## **Bayside Planning Panel**

Item No	5.3
Application Type	Development Application
Application Number	DA-1997/49/F
Lodgement Date	3 August 2017
Property	<b>339-377 Forest Road, Bexley</b>
Owner	Coptic Orthodox Church (NSW) Property Trust
Applicant	Mr Talaat Nasralla
Proposal	Proposal to remove ten (10) trees within the site
No. of Submissions	Two(2) letters of objection and one(1) petition (57 signatures)
Cost of Development	N/A – S96
Report by	Helen Lai, Student Town Planner Marta Gonzalez-Valdes, Coordinator Major Assessments

## Section 96(1A) – Delegated Report

Application Number:	DA-1997/49/F
Date of Receipt:	3 August 2017
Property:	339-377 Forest Road, BEXLEY NSW 2207 Lot 11 DP 857373
Owner:	Coptic Orthodox Church (NSW) Property Trust
Applicant:	Mr T Nasralla
Proposal:	To remove ten (10) trees within the site
Recommendation:	PARTIAL APPROVAL
No. of submissions:	Two(2) letters and one(1) petition containing fifty-seven(57) signatures
Author:	Helen Lai – Student Town Planner Marta M Gonzalez-Valdes – Coordinator Development Assessment
Date of Report:	16 October 2017

**Appendix C – Plan (aerial Photograph) Showing location of subject trees – 339 Forest Road, Bexley NSW.**

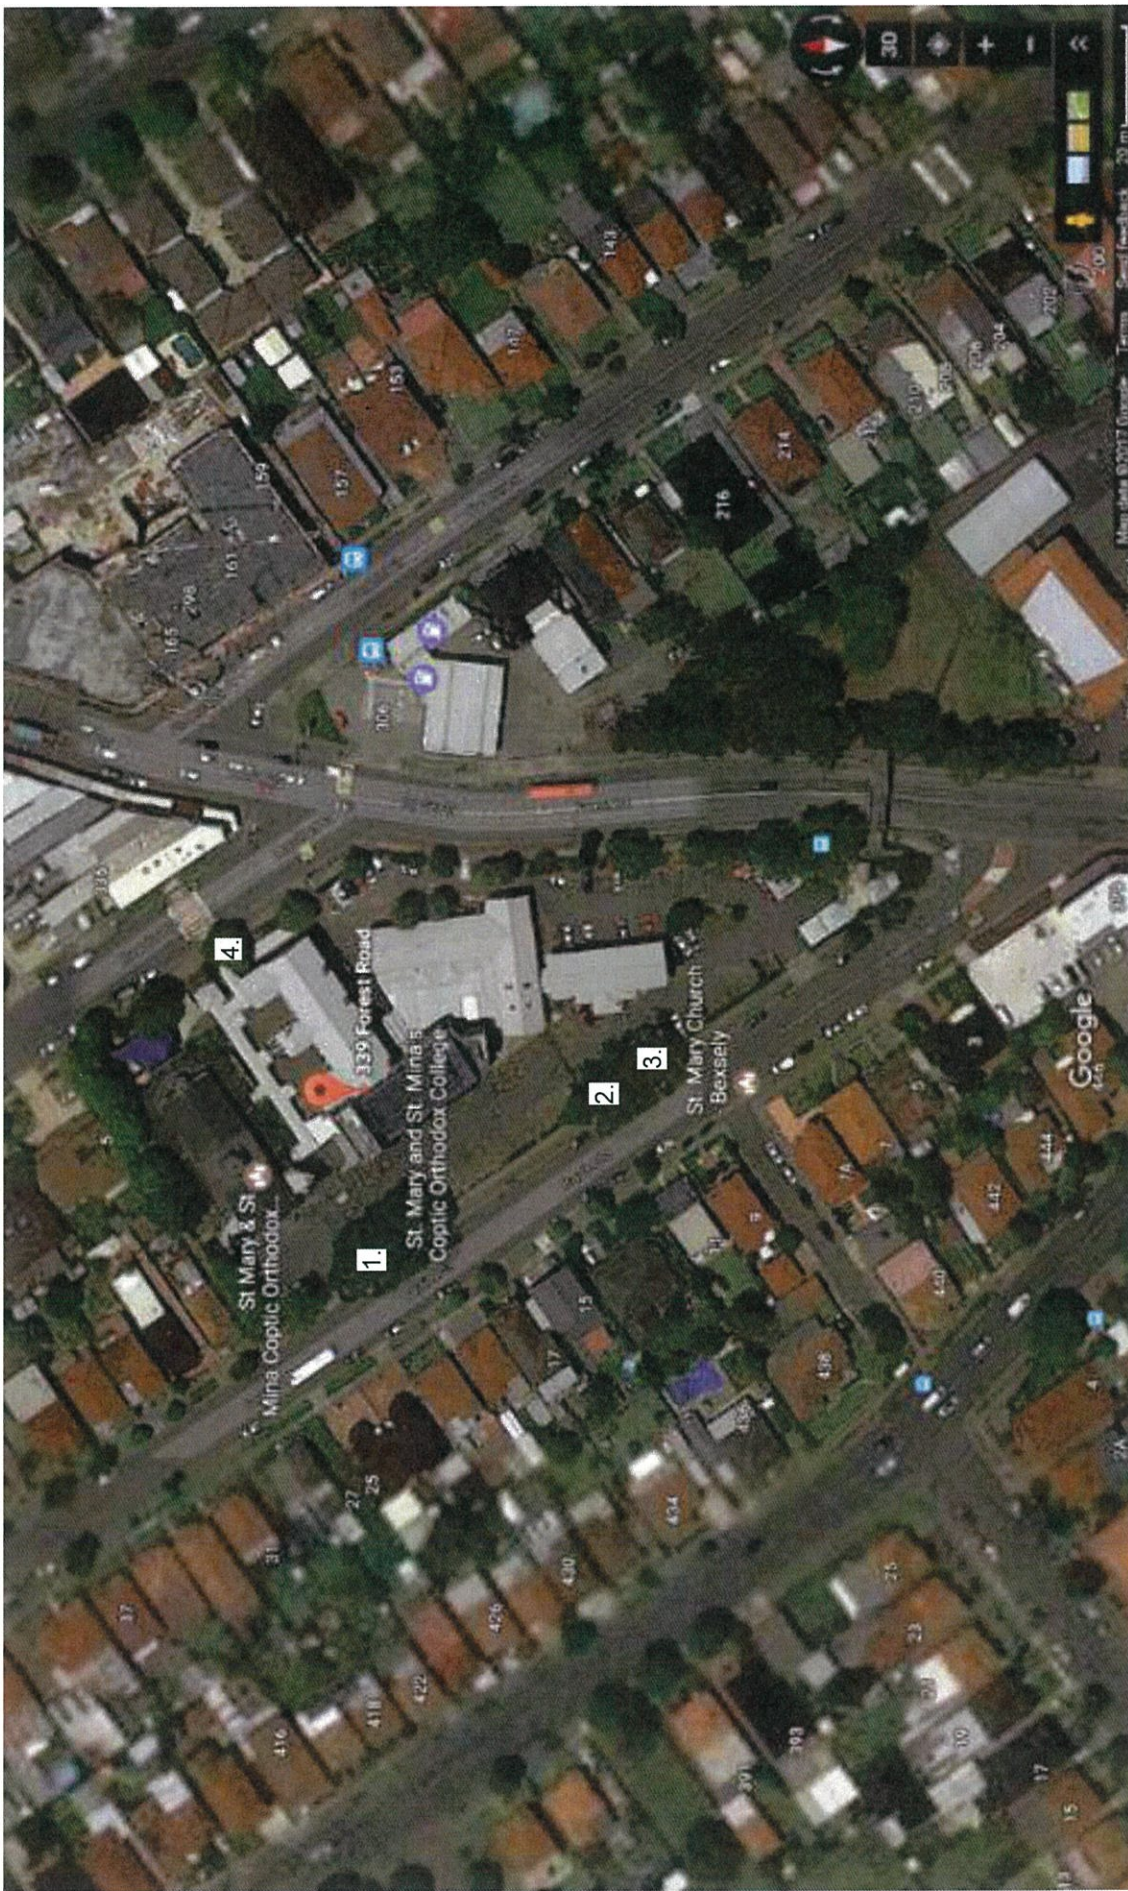
A Tree Risk Assessment Report prepared by a qualified Arborist has recommended the removal of Trees No. 1-4 to be replaced with suitable new plantings. However, following the site meeting with the Consultant Arborist engaged by the applicant, Council's Tree Management Officer has recommended the removal of Trees No. 3 and 4 only. Tree 3 identified as the Southern Blue Gum (*Eucalyptus globulus*) located adjacent to Bayview Street is in fairly poor condition with borer damage and a large cavity at 6 metres from the ground, which compromises the structural integrity of the tree. Tree 4 identified as the Camphor Laurel (*Cinnamom camphora*) located adjacent to Broadford Street is also supported for removal as the tree is causing damage to adjacent structures and far from fully grown.

Therefore, Trees No. 3 and 4 may be removed. No other site trees within the site may be removed. At least two (2) x 75 litre locally indigenous replacement trees shall be planted within the site along Bayview Street and Forest Road boundaries.

*85B. Notwithstanding condition 85A above, the Southern Blue Gum tree (Tree No. 3), located adjacent to Bayview Street and the Camphor Laurel tree (Tree No. 4) located adjacent to Broadford Street as identified in the Tree Risk Assessment Report dated 29 May 2016 and prepared by Urban Tree Management may be removed. During the removal of Tree No. 3 all care is to be taken to prevent any damage to Tree No. 2. No other site trees within the site may be removed. At least two(2) x 75 litre locally indigenous replacement trees shall be planted within the site on the Bayview Street and Forest Road boundaries following removal of the trees.*

**Figure 2: Aerial view of site. – The 10 subject trees are along Bayview Street and Broadford Street as shown above.**

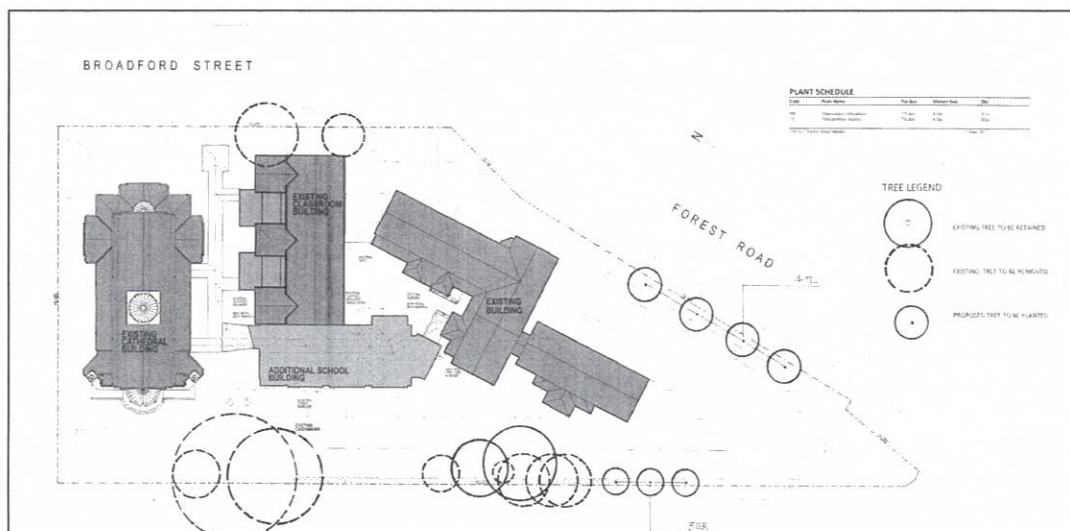
- The proposal seeks consent for the removal of ten(10) trees as shown in the submitted Landscape Plan. However, the Tree Risk Assessment Report submitted by the applicant only referred to four(4) trees. The applicant advised that the application would only pursue the removal of four(4) trees as recommended in the Tree Risk Assessment Report. Council's Tree Management Officer has reviewed the information and concurs with the recommendation to remove Trees No. 3 and 4 (Southern Blue Gum and Camphor Laurel) subject to replacement trees being planted on site. However, recommends the retention of Trees 1 and 2 (Southern Blue Gums) as well as remedial pruning of those trees.
- The site is identified as Heritage Item 131 on Schedule 5 of Rockdale LEP2011 – Original Bexley School Buildings. Council's heritage advisor supports the proposal.

The applicant was requested to provide additional information in support of the removal of Trees No. 5-10 as identified in the Landscape Plan, however, the applicant advised they did not want to pursue removal of those trees but only the ones identified in the Tree Risk Assessment Report. Thus, in the absence of supporting evidence provided to Council only Trees No. 1-4 as indicated in the Landscape Plan and Tree Risk Assessment Report have been considered in the assessment of this application.

Following the assessment of the information submitted and for the reasons explained in this report only the removal of trees 3 and 4 is supported. The approved modification involves the inclusion of the additional conditions as follows:
